STAFF REPORT
COMMUNITY DEVELOPMENT DEPARTMENT

HEARING DATE: 2/17/2026
TO: Mayor & City Council
FROM: Nick Napoli, Associate Planner
208-884-5533
SUBJECT: Rosalyn Subdivision
MFP-2025-0003
LOCATION: Located at 200 E. Rosalyn Drive (Parcel #'s R7699020020 and R2114050060)

Modification to the final plat (H-2023-0056) approval to decrease the buildable lots from three (3) to two (2) across 0.733 acres of land in the R-8 zoning district for Rosalyn Subdivision.

A. Approved Final Plat (dated: 07/23/2024)

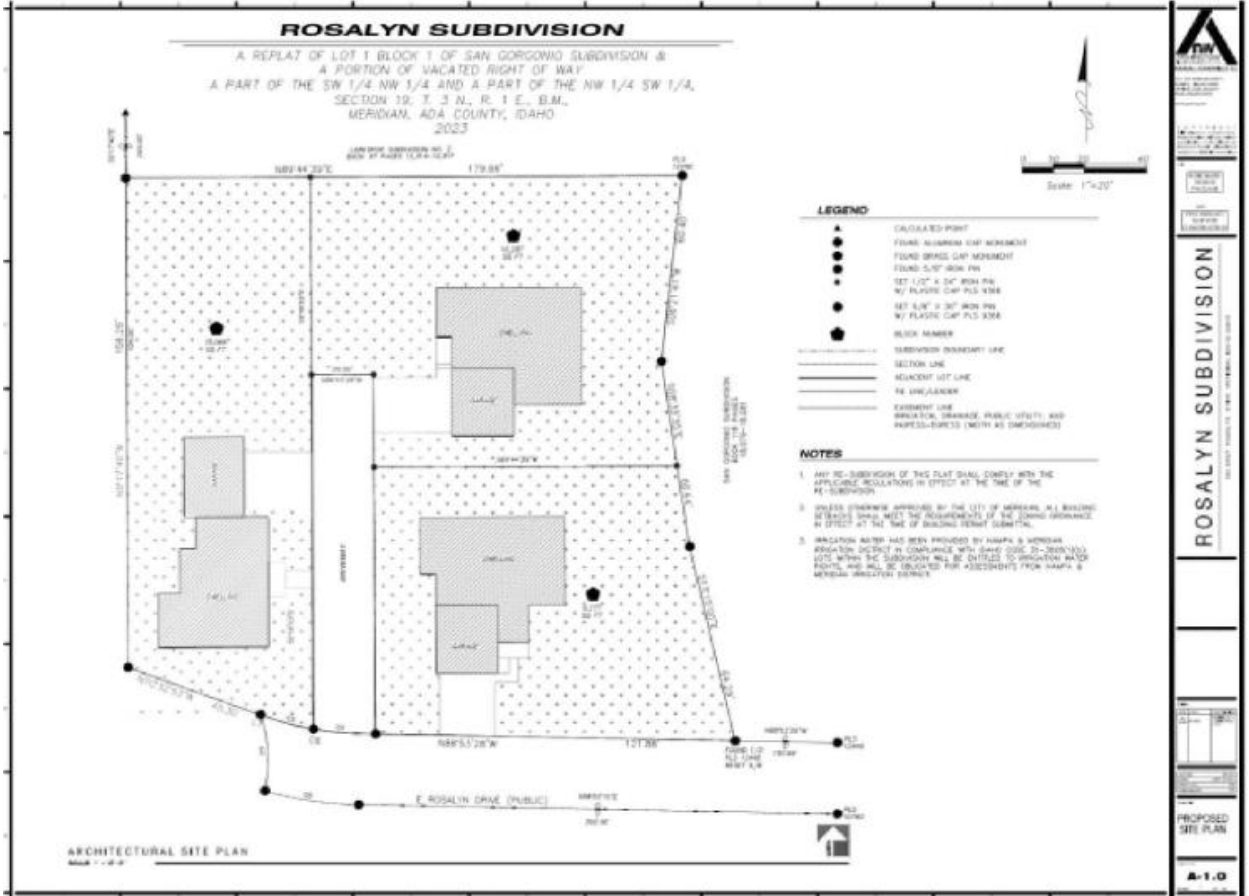
The preliminary plat (H-2023-0056) for Rosalyn subdivision was approved by City Council in 2023. At the time, the applicant was approved for three (3) buildable lots with a common drive accessing two of the lots. However, the applicant is now requesting to reduce the number of lots from three (3) to two (2) and eliminating the common drive as both lots will have direct access to Rosalyn Drive. The average lot size is now proposed to be 15,779 square feet which is consistent and larger than the surrounding developments.

In addition, the revised layout will allow for the existing home to remain in its current location without needing to be removed or relocated. The applicant currently has an accessory dwelling unit being built on the property with the existing home which complies with the dimensional standards for

B. Proposed Final Plat (dated: 8/13/2025)

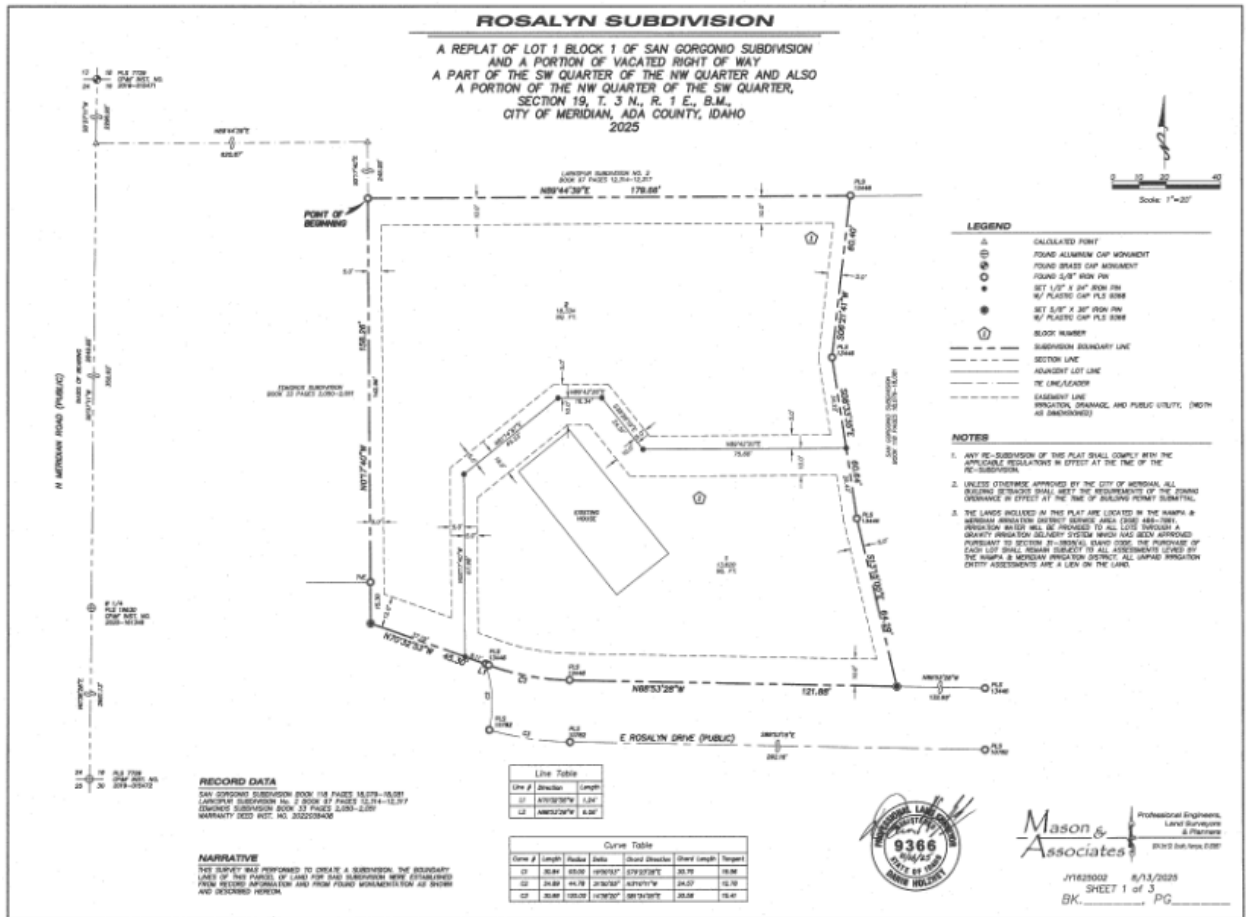
1. Future development of this site shall be generally consistent with the preliminary plat, landscape plan, and conceptual building elevations included in Section VIII and the provisions contained herein.

2. The final plat prepared and signed by Darin Holzhey with Mason and Associates on 10/06/2025 is approved as submitted; the revised construction drawings shall be submitted with the final plat application for the City Engineer's signature.

3. The applicant shall submit and gain approval of a design review application for the single family attached units on Lot 2, Block 1 prior to submittal of building permits on Lot 2, Block 1.

4. The proposed plat and subsequent development are required to comply with the dimensional standards listed in UDC Table 11-2A-6 for the R-8 zoning district.

5. Prior to the City Engineer's signature on the final plat, all existing structures that do not conform to the setbacks of the R-8 zoning district shall be removed.
